ADDENDUM NO. 2

Reference: Woodbury Business Building Remodel
Utah Valley University – Orem, Utah
DFCM Project No. 09171790

ADDENDUM #02 to the “Construction Documents”

Addendum #02

REVISIONS:
 ADDENDUM #1 3-29-10
 ADDENDUM #3 4-19-10
 PROJECT NO.: 09031
 DATE: 2/16/10
 SHEET: AE6-01

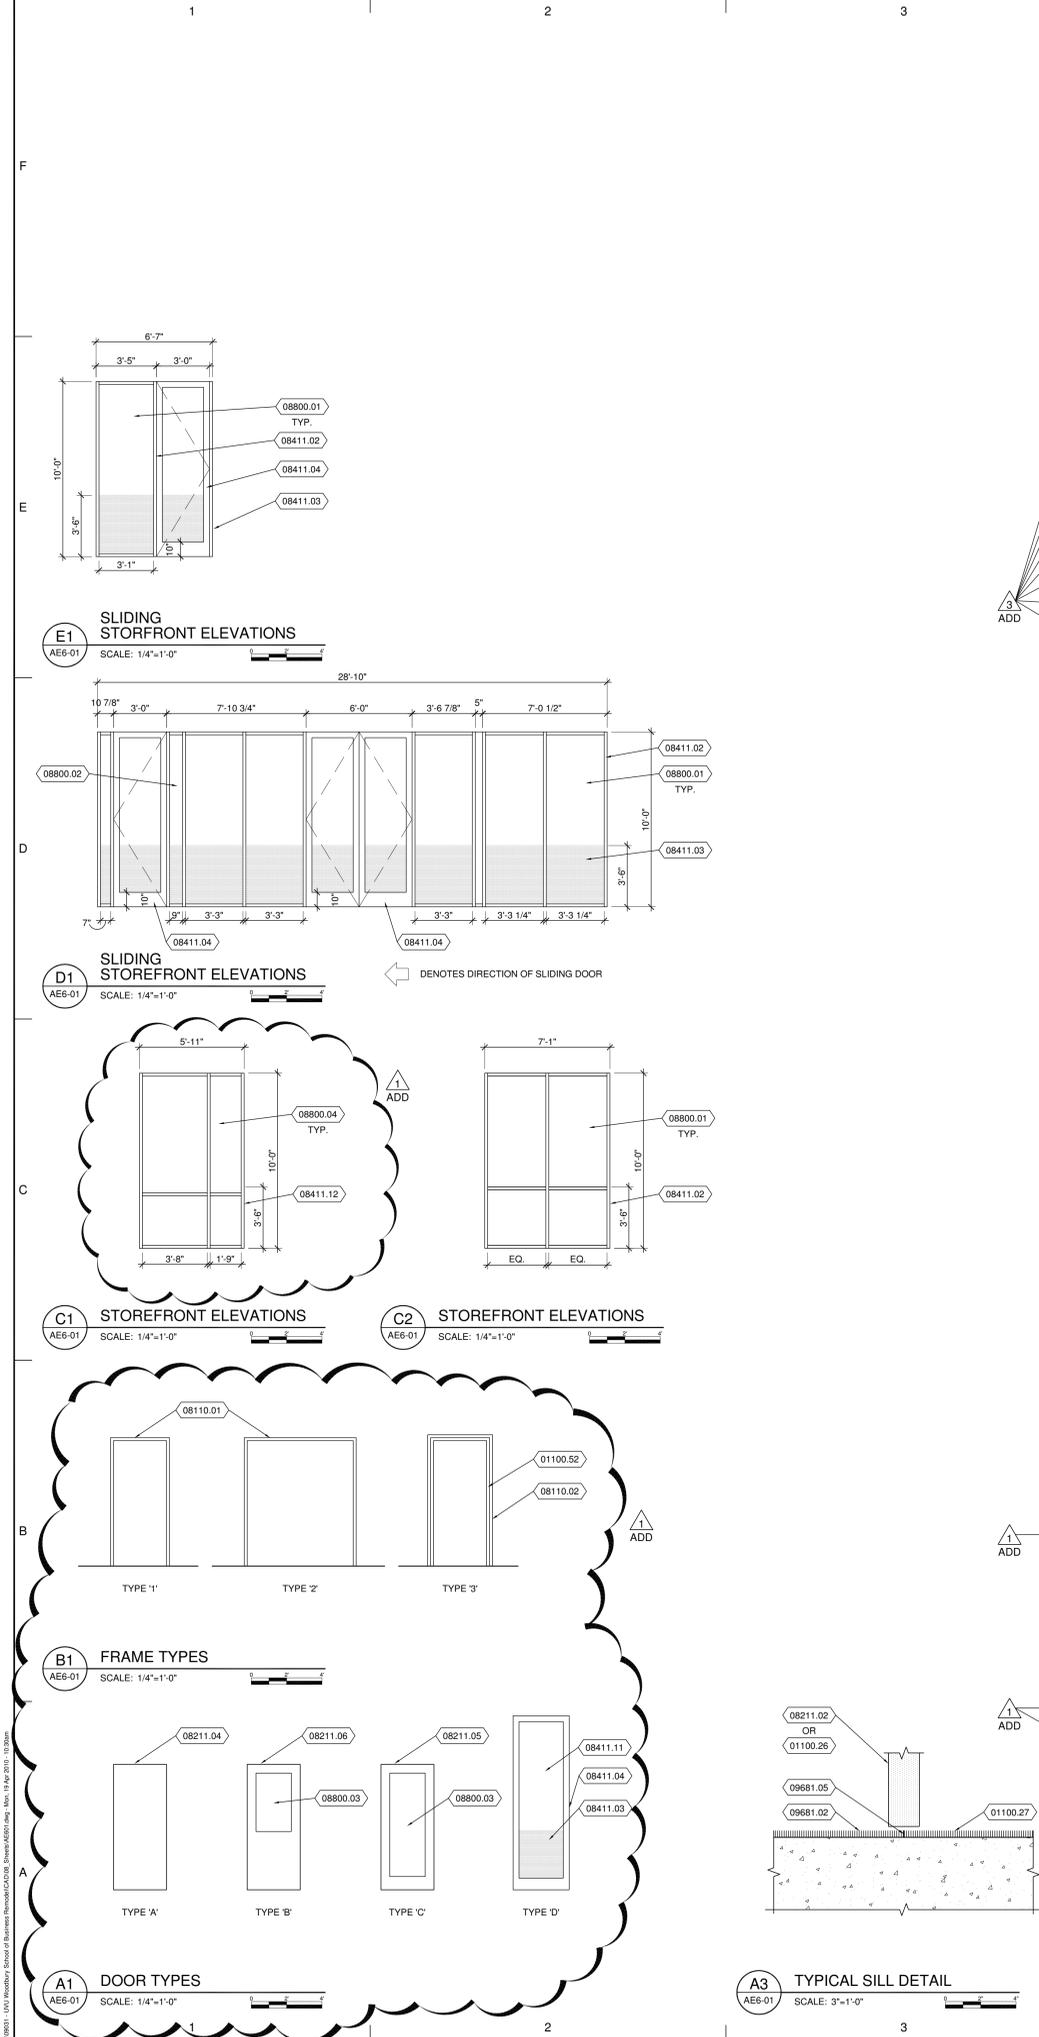
03.01 SHEET AE6-01

Change: Level Two Finish Schedule “Corridors 200A-200H”, Column “Door and Trim”
Changed to “Exist.” The existing doors in these corridors are not to be re-finished.
